**Environmental
Resources
Management**

24 January 2007

Subject: Former Arkema Portland Plant
Responses to ODEQ Comments on the Upland Remedial
Investigation Report, Lots 3 & 4 and Tract A
ECSI No. 398

Figure 8
1,2-Dichlorobenzene Concentrations
 Arkema Inc.
 Portland, Oregon

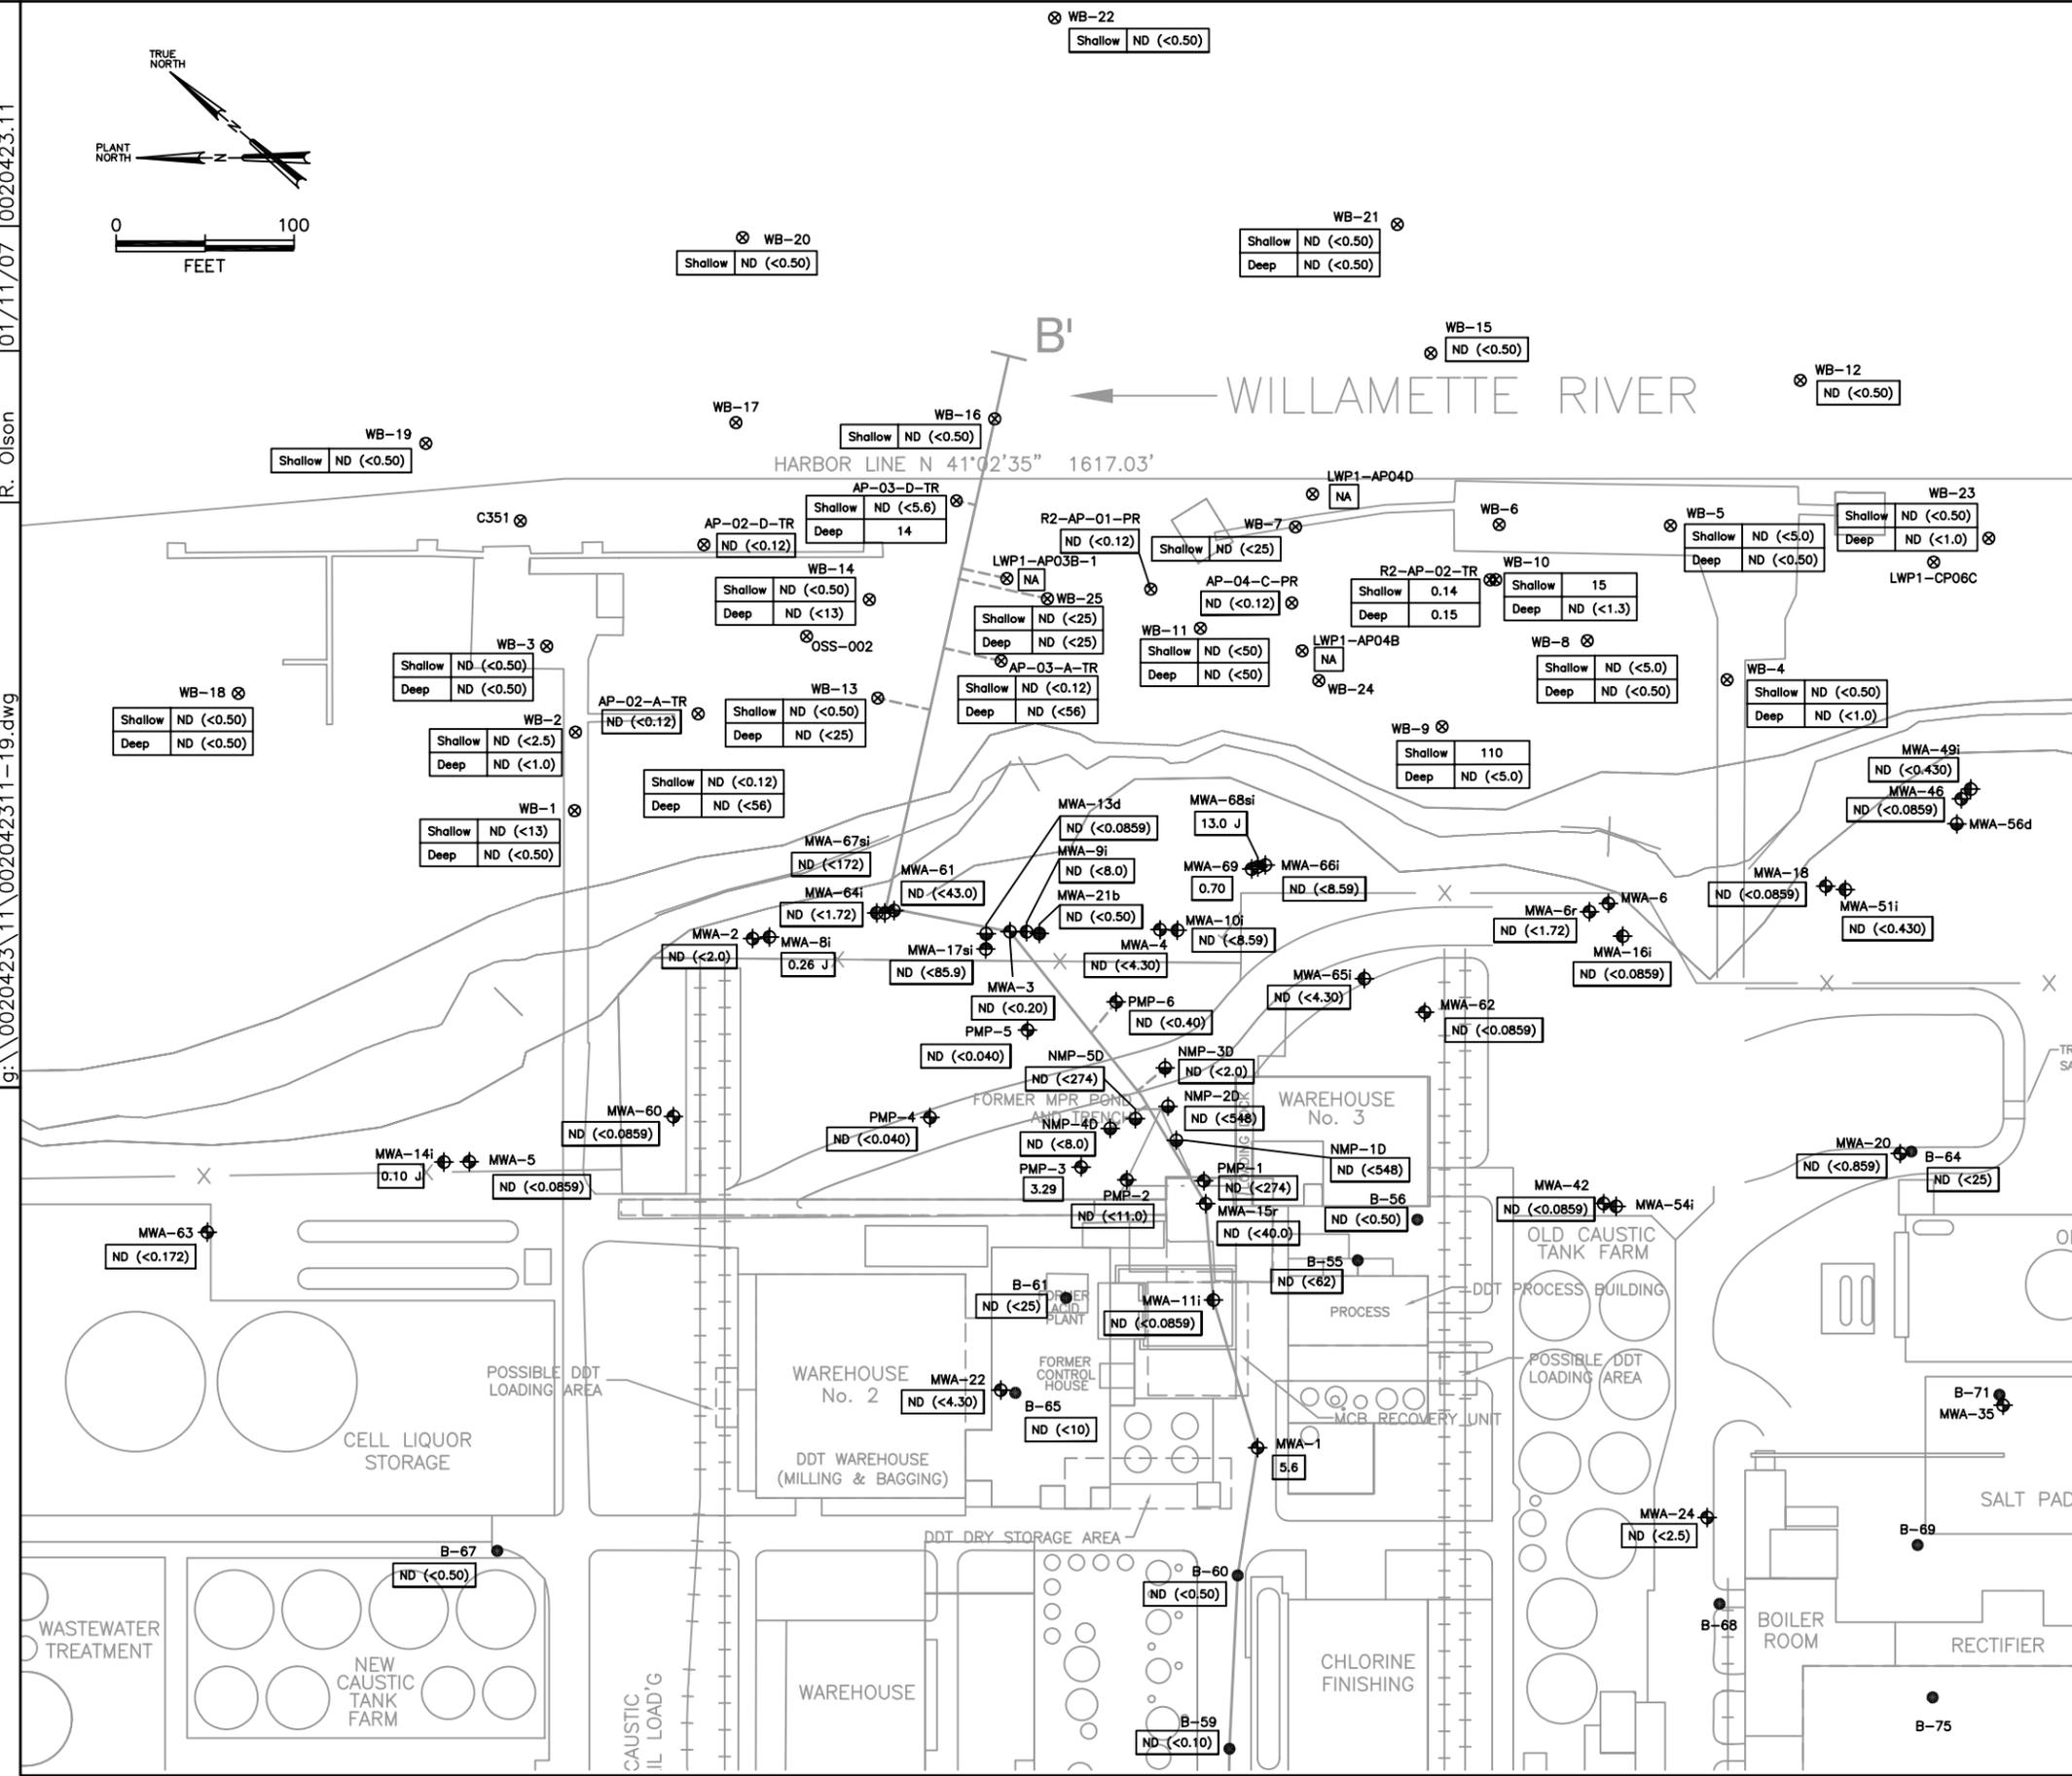
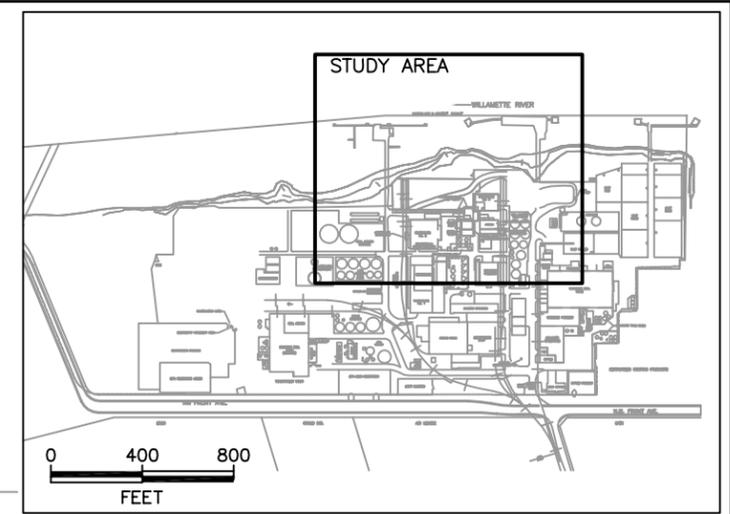
Comment 1 - The plan view figures prepared for acetone, carbon tetrachloride, chloroform, 1,2-dichlorobenzene, 1,3-dichlorobenzene, 1,4-dichlorobenzene, tetrachloroethene, 1,1,1-trichloroethane and trichloroethene did not include available Lower Willamette Group in-water data (LWG). Please update these figures to include the LWG sediment, groundwater and transition zone pore water data.

Lower Willamette Group (LWG) groundwater and transition zone data have been added to the figures as requested. Revised figures are included as Attachment A. Sediment data have not been included as these data are not directly comparable to dissolved phase groundwater and transition zone water data. The LWG data presented on the figures were obtained from:
